Access Compliance Report

Public Rights-of-Way

Intersection ID: 15624	Main Street: ORDERMORE_AV	Cross Street: SCOTT_AV	Location: S
ADA ID: 790D5F684CB7	Ramp Type: PerpDiag	Initial Pass/Fail: Fail	Overall Compliance: No
		Severity Score: 12.5

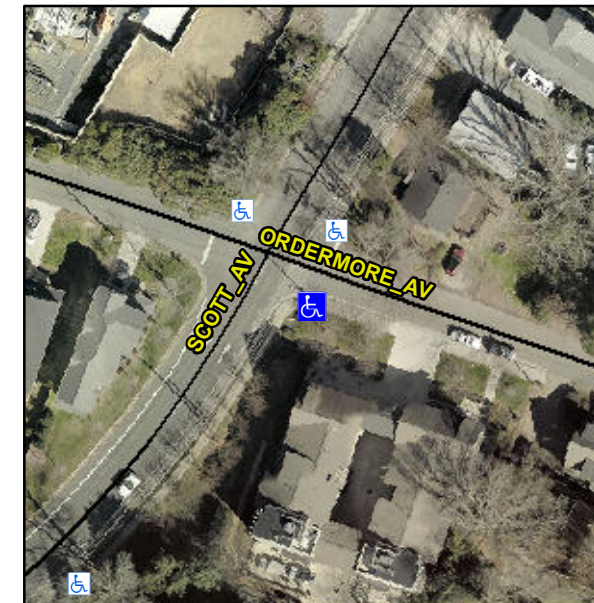
Not Found, R304.2.2

Compliance	Description	Data	Compliance	Description	Data
N/A	Ramp Length (in)	70.0	No	Ramp Slope (%)	8.5
Yes	Ramp Width (in)	48.0	Yes	Ramp XSlope (%)	2.0
N/A	Flare Type LT	N/A	N/A	Flare Type RT	N/A
N/A	Flare Slope LT (%)	N/A	N/A	Flare Slope RT (%)	N/A
N/A	Flare Traversable LT?	N/A	N/A	Flare Traversable RT?	N/A
N/A	Landing Length (in)	N/A	N/A	DWS Provided?	N/A
N/A	Landing Width (in)	N/A	N/A	DWS Contrast?	N/A
N/A	Landing Slope (%)	N/A	N/A	DWS Length (in)	N/A
N/A	Landing X Slope (%)	N/A	N/A	DWS Full Width?	N/A
N/A	Landing Curb? (Y/N)	N/A	N/A	DWS Offset (in)	N/A
N/A	Shared Landing?	N/A			
N/A	Gutter Ponding?	N/A	N/A	Gutter Slope (%)	N/A
N/A	Gutter Lip Ht (in)	N/A	N/A	Gutter X Slope (%)	N/A
N/A	Painted X Walk1?	No	N/A	Painted X Walk2?	No
	X Walk 1 Direction	To NE		X Walk 2 Direction	To NW
N/A	X Walk 1 Width (in)	N/A	N/A	X Walk 2 Width (in)	N/A
	X Walk 1 Slope (%)	3.9		X Walk 2 Slope (%)	1.2
	X Walk 1 X Slope (%)	4.4		X Walk 2 X Slope (%)	2.6

Remove & Replace Curb Ramp With Two New Directional Ramps or Equivalent.
